## **Project Scope**

### **Scope Overview**

The marina expansion project includes the following primary project elements:

This proposed marina expansion is illustrated in the following figure for reference, noting that this figure is taken from Sheet 3 of the provided Permit Drawings.

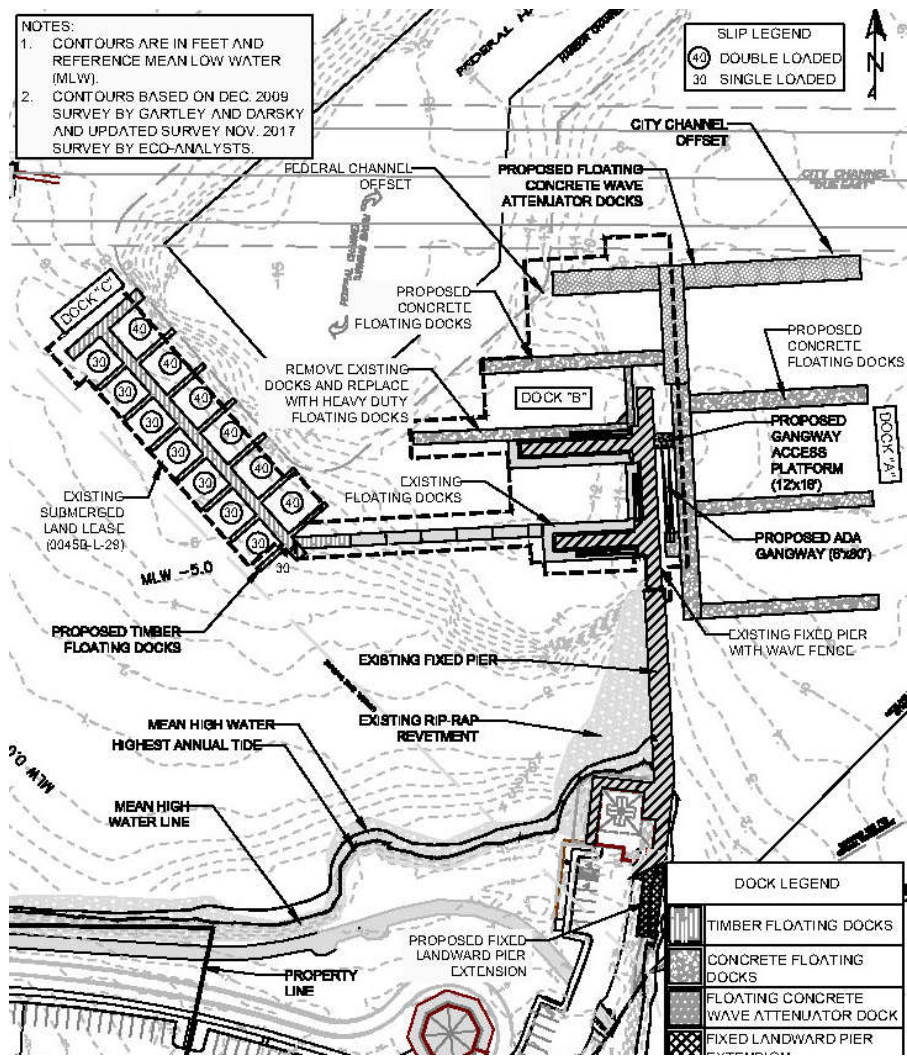
Dock A includes a total of ~~15,874~~ 15,784 sf of new floating dock area, ~~6,800~~ 7,400 sf of which will be Wave Attenuating Docks. The floating docks will be anchored via a maximum of ~~55~~ 39 piles (see subsequent discussion regarding piles).

The Dock B improvements include removal of 1,628 sf of existing timber floating docks and installation of 4,023 sf of new floating concrete docks. The floating docks will be anchored via a maximum of ~~20~~ 13 piles (see subsequent discussion regarding piles).

Dock C includes a total of 5,611 sf of new floating timber docks, which will be anchored via a maximum of ~~40~~ 32 piles (see subsequent discussion regarding piles).

- Floating Concrete Docks (Dock A): Assume steel pipe piles 16” diameter.  
~~55~~ 24 piles@1.4 sf/each= ~~77~~ 33.6 sf direct impact
- Floating Concrete Attenuation Docks (Dock A): Assume steel pipe piles 20” diameter. ~~20~~ 15 piles@2.2 sf/ea= ~~44~~ 33 sf direct impact

- Floating Concrete Docks (Dock B): Assume steel pipe piles 16” diameter.  
~~55~~ 13 piles@1.4 sf/each= ~~77~~ 18.2 sf direct impact  
Remove 9, 12” wood piles 9 sf  
Net impact = ~~68~~ 9.2 sf

- Floating Timber Docks (Dock C): Timber piles 12” in diameter  
~~40~~ 32 piles@1 sf/ea=~~40~~ 32 sf direct impact
